Façade Design

Revised Tower Façade Design - North Facade Glare

Response to Glare issues on the hotel North Facade

B4N - Hotel - North Elevation, NTS

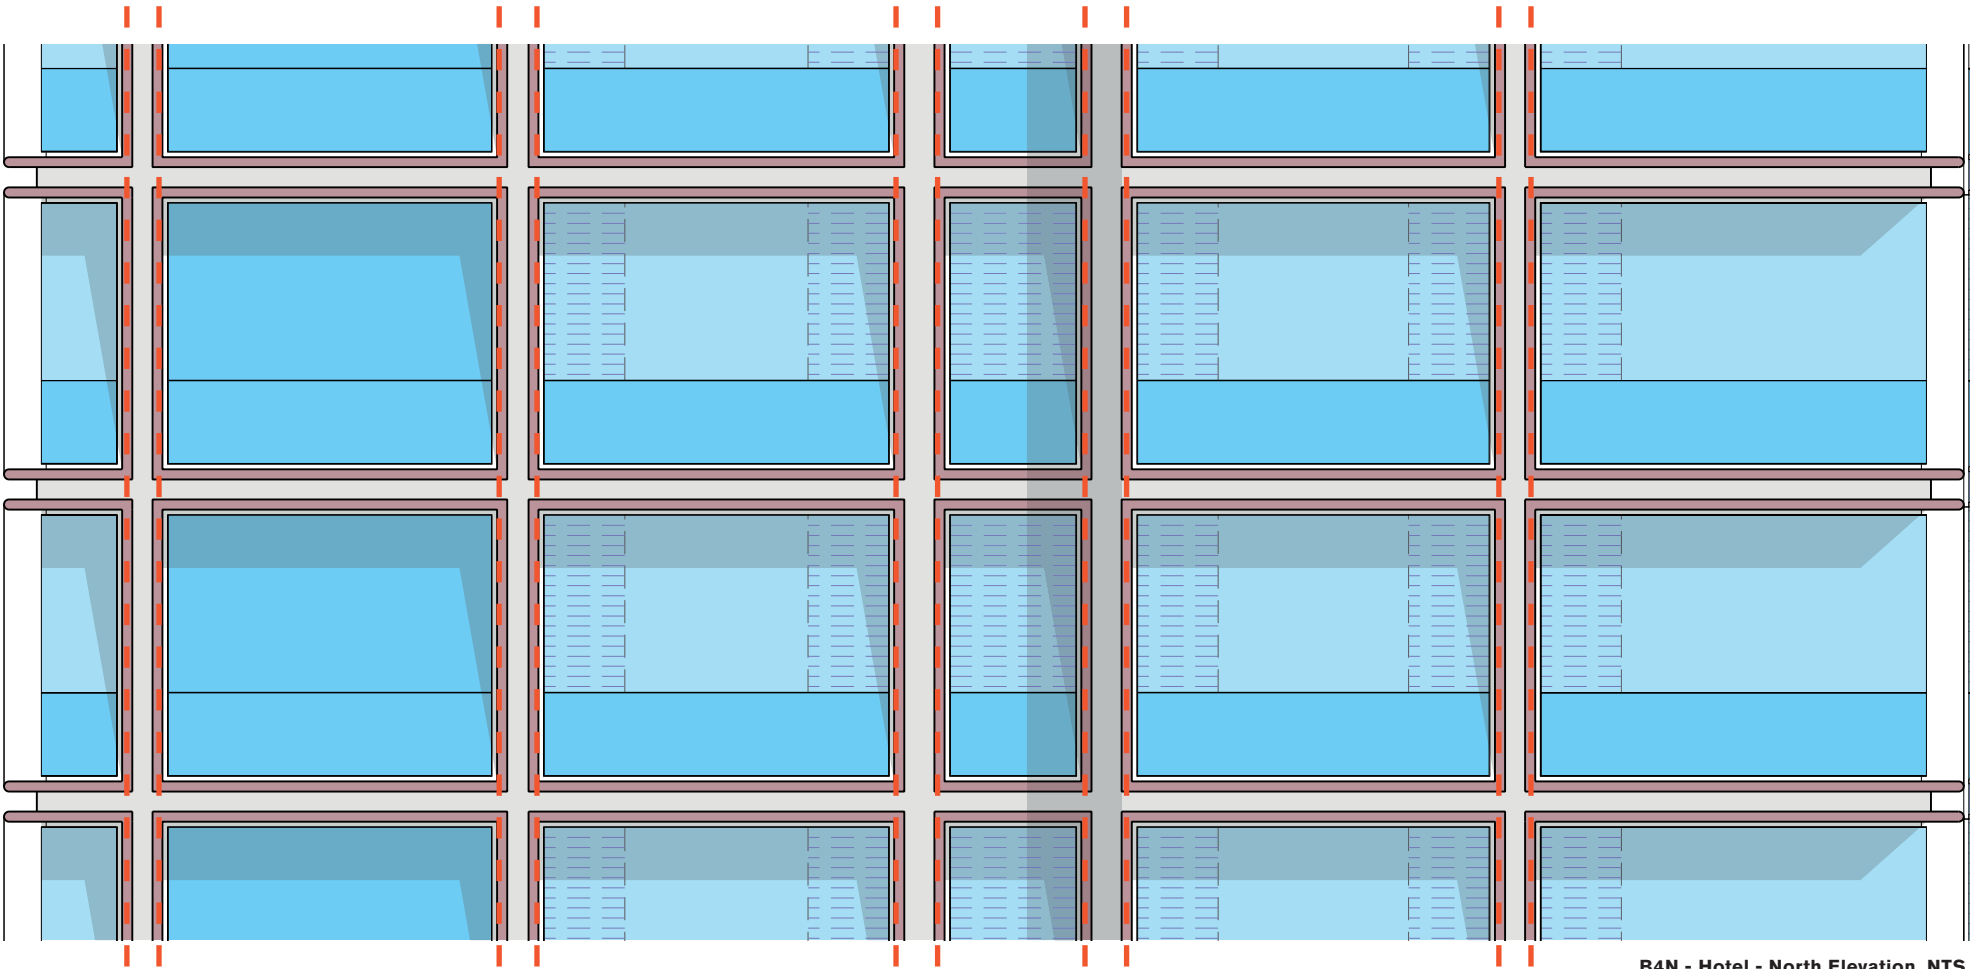
On the northern façade, vertical fin elements to the glazing have been recommended to intercept morning and afternoon solar rays reflecting onto Broadway (see Solar Reflectivity Assessment 4946 for Frasers Broadway, submitted in March 2009 by CPP). Anti glare measures have been incorporated within the cladding module of the hotel itself as each individual unit has been separated from the other by a double vertical fin which protrudes from the outer glazing line.
